## IMPORTANT INFORMATION

### Genie S WIRING

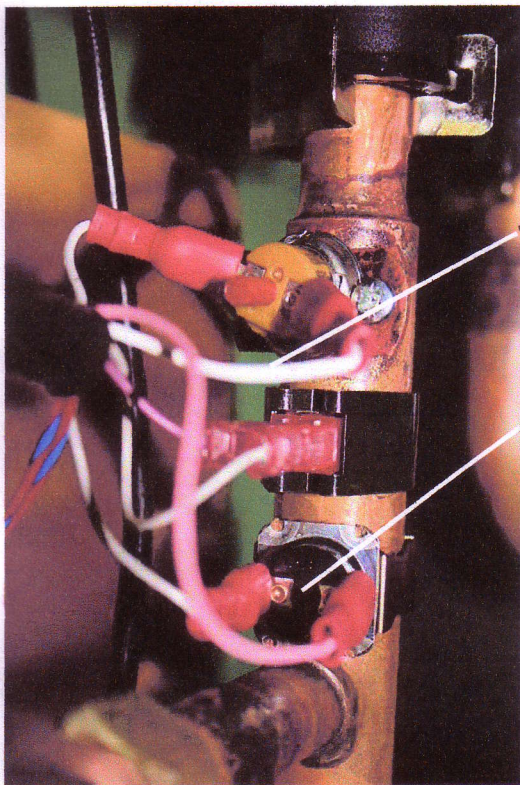
It has been discovered that some Genie S Pool Heaters have been wired incorrectly and two thermostats have been reversed. This covers the serial number range from 08960 to 099447.

In the normal operation of the appliance neither of these two thermostats will be operating and so it is very possible that the unit will run completely normally. If however the appliance is exhibiting a number of 'GAS' alarms on its display, that can be reset by the panel reset button alone, this will be the cause.

**INCORRECT**

Two Whites

Pink & Grey

The Manufacturer recommends that the wiring is checked and where necessary corrected for all Genie S models in the above serial number range, when you have competent engineer on site.

The correction is the reversing of the two pairs of wires as per the photos below.

**CORRECT**

Two Whites
